SUBJECT: STALL WARNING SWITCH, CIRCUIT MODIFICATION

MODEL/S/N
AFFECTED: MOONEY M20J, S/N 24-3201, 24-3218 THRU 24-3257
MOONEY M20L, S/N 26-0001 THRU 26-0041
MOONEY M20M, S/N 27-0001 THRU 27-0134

REVISION A IS REQUIRED TO CORRECT SCHEMATICS (PAGE 2) FOR MODIFICATION.

FIGURE SI M20-91-1

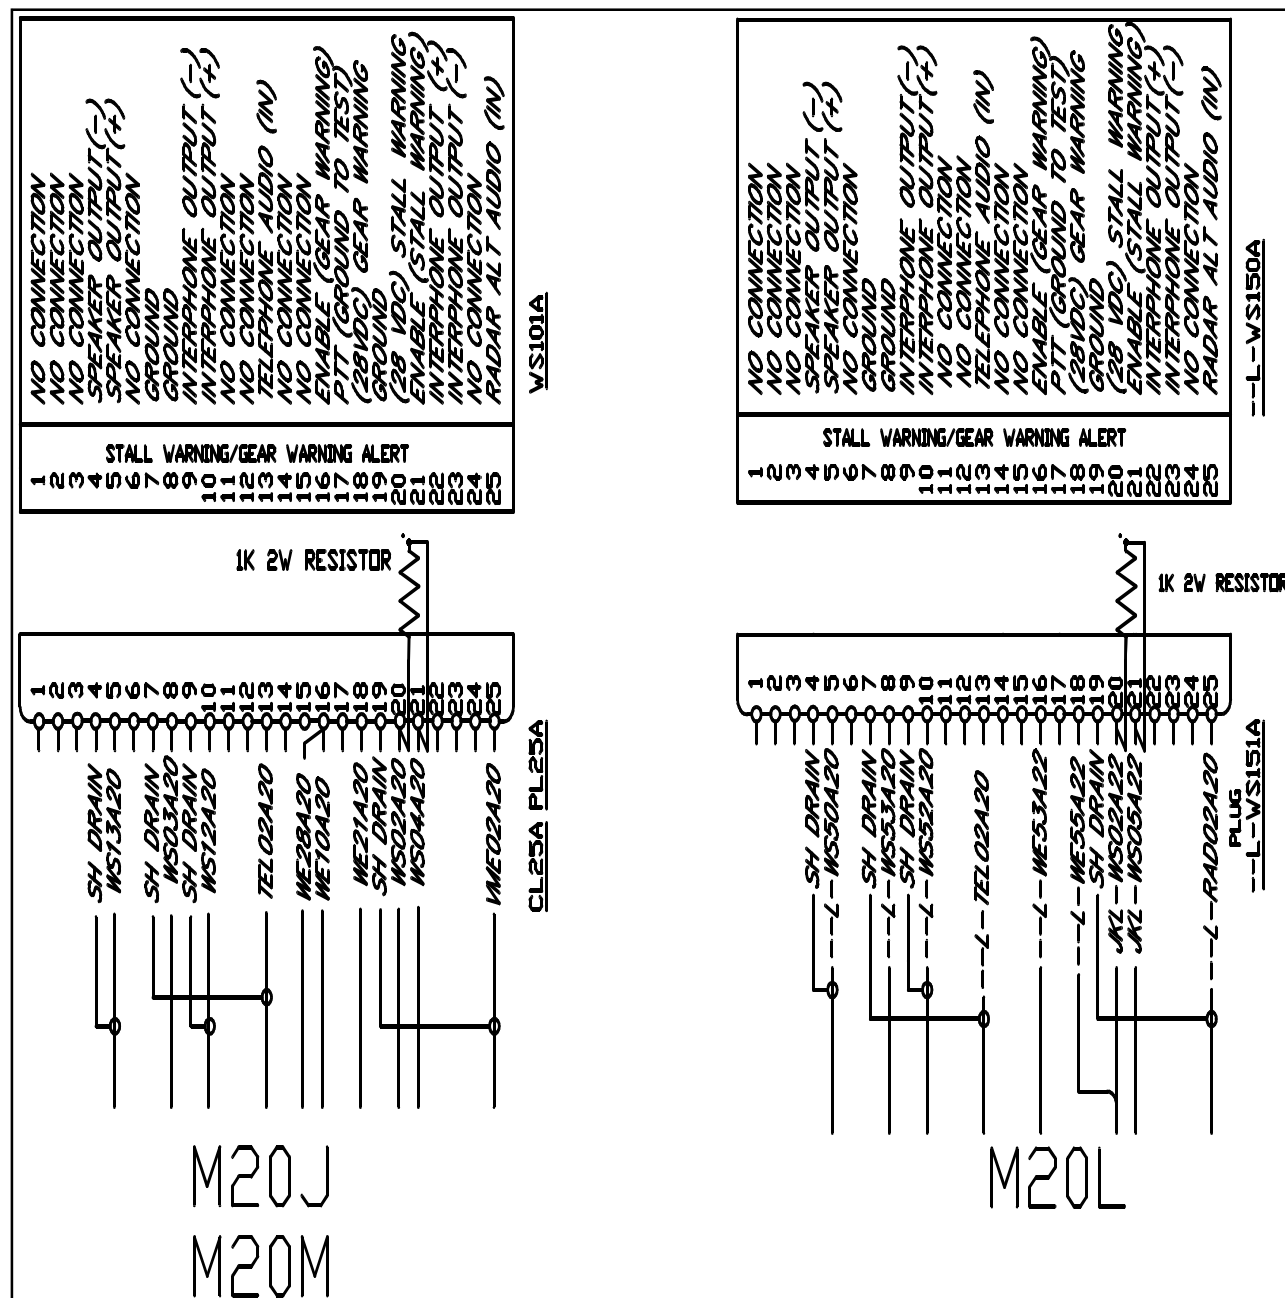
3. Select the applicable schematic (M20J - M20L - M20M) shown in Figure SI-M91-1 and solder the MIL-R-11-RC42, 1K 2W resistor, (RC42-HB-102-J, included in kit) to the correct numbered connectors. The resistor must be positioned so it will not interfere with the connection of the wire harness back to the tone generator. Protect the resistor with heat shrink or other insulation.
